Team Update 12

Team Update 11

Team Update 10

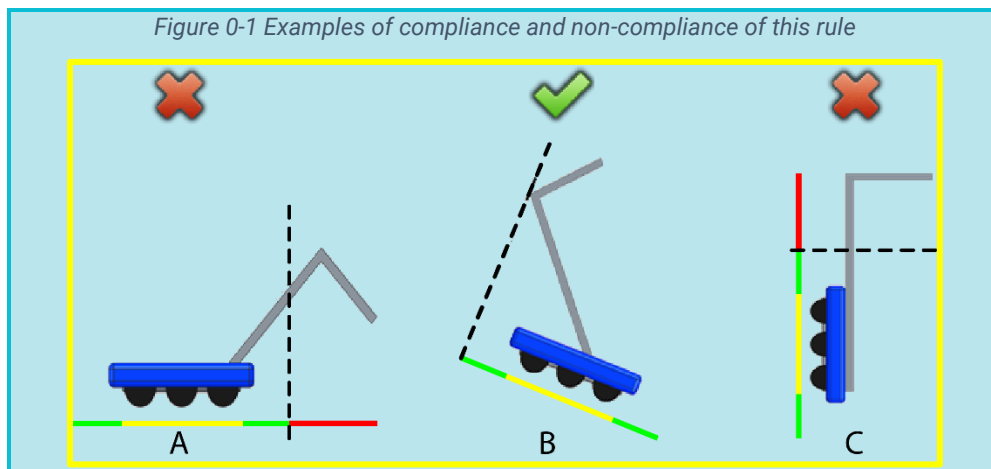
G107 *Figure 7-2, example C has been modified to show the extension reaching beyond the ROBOT'S FRAME PERIMETER.*

Figure 6-1 MATCH setup

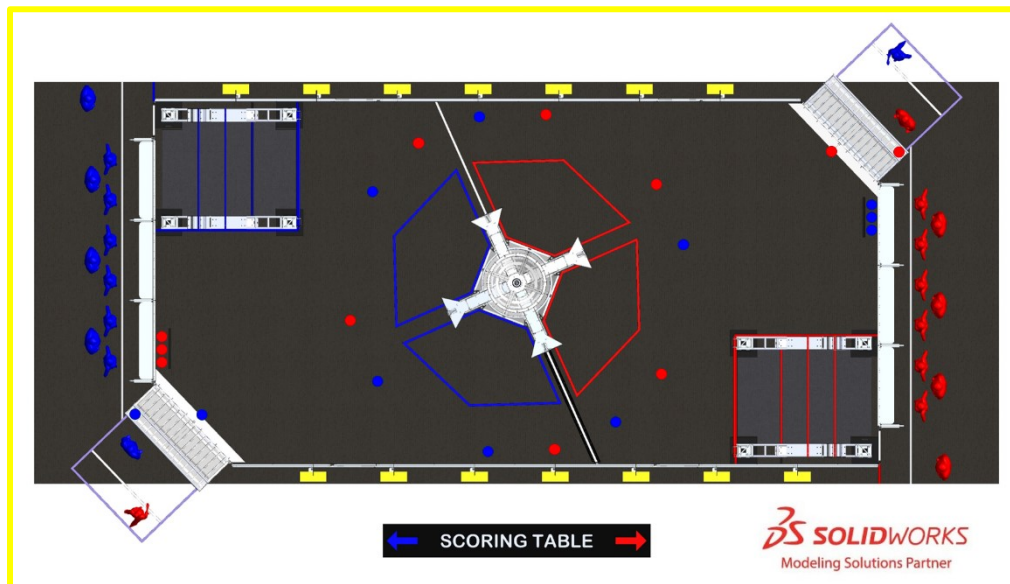
Figure 6-1 is updated to correct the starting location for CARGO not staged in ROBOTS.
